Access Compliance Report

Public Rights-of-Way

| Intersection ID: 44871 | Main Street: CONLAN_CR | Cross Street: HUFFINES_LN | Location: SE |
| ADA ID: 694FC427A143 | Ramp Type: PerpDiag | Initial Pass/Fail: Fail | Overall Compliance: No |

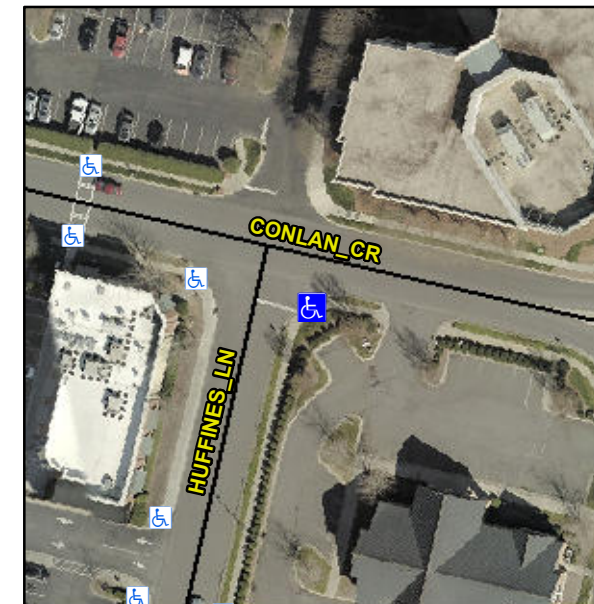
Not Found, R304.5.1, R304.2.2, R304.5.3

| Compliance | Description | Data | Compliance | Description | Data |
|------------|-----------------------|-------|------------|-----------------------------|-------|
| N/A | Ramp Length (in) | 60.5 | No | Ramp Slope (%) | 8.6 |
| No | Ramp Width (in) | 39.0 | No | Ramp XSlope (%) | 3.8 |

Remove & Replace Curb Ramp With Two New Directional Ramps or Equivalent.
